From: <mkleisure@firstenergycorp.com>
To: <jbh1@nrc.gov>
Date: 8/23/02 2:01PM
Subject: RE: NRC Request re: Cavity Mold

*M. Leisure, F&NOC
J. Hopkins, NRC*

Top View – Damaged CRDM Opening

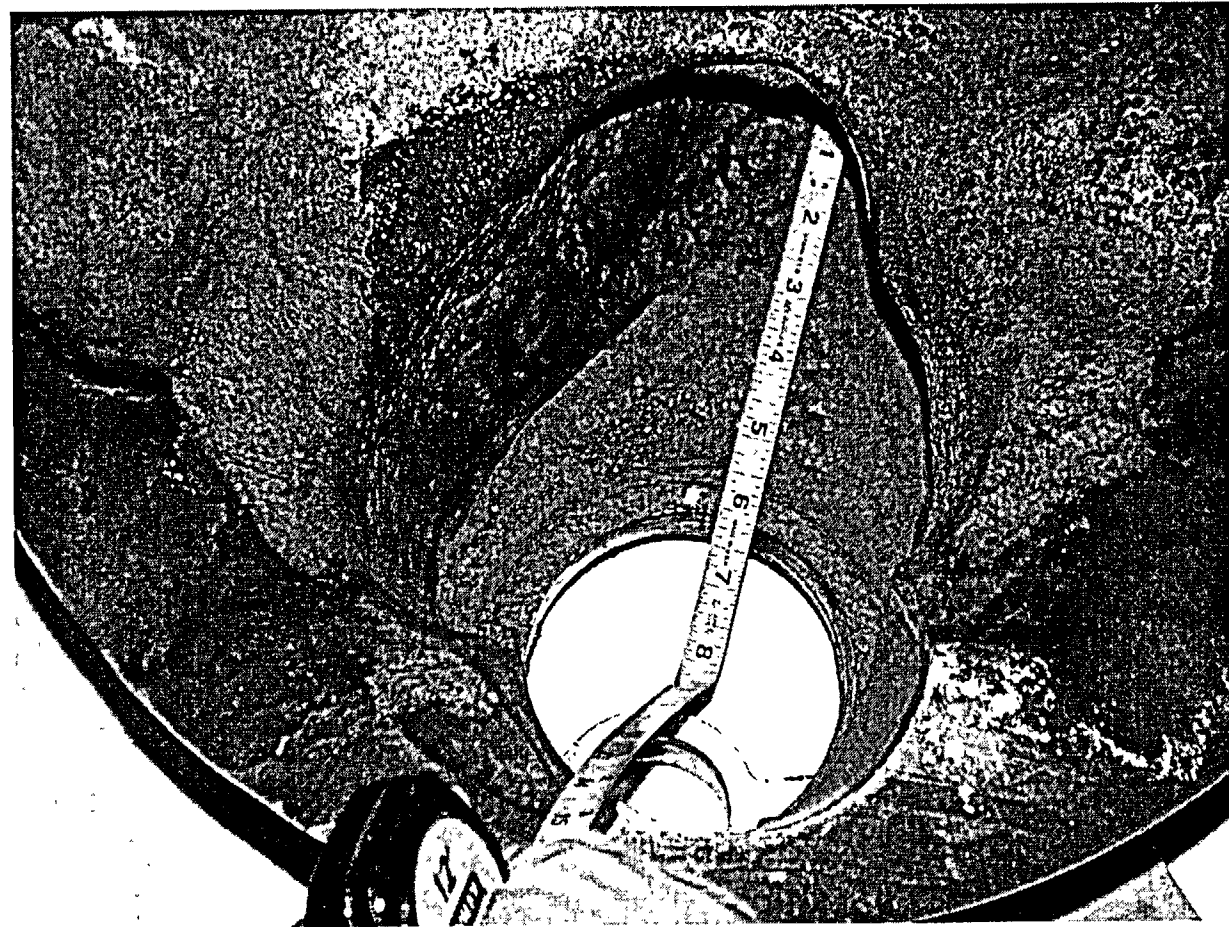
I just faxed you a couple of pages regarding an NRC request on the maximum dimension from the nozzle to the nose of the cavity. Please call me when you've had a chance to review the fax.

Based on the photos (particular slide #12) in the 6/17/02 presentation at BWXT and photos for the exposed cladding area measurement (word doc in my 8/7/02 email to you), the shortest distance from the nozzle #3 O.D. to the extremity of the cavity (i.e. the farthest point of the nose) is estimated to be 5.9+/- 0.2 inch.
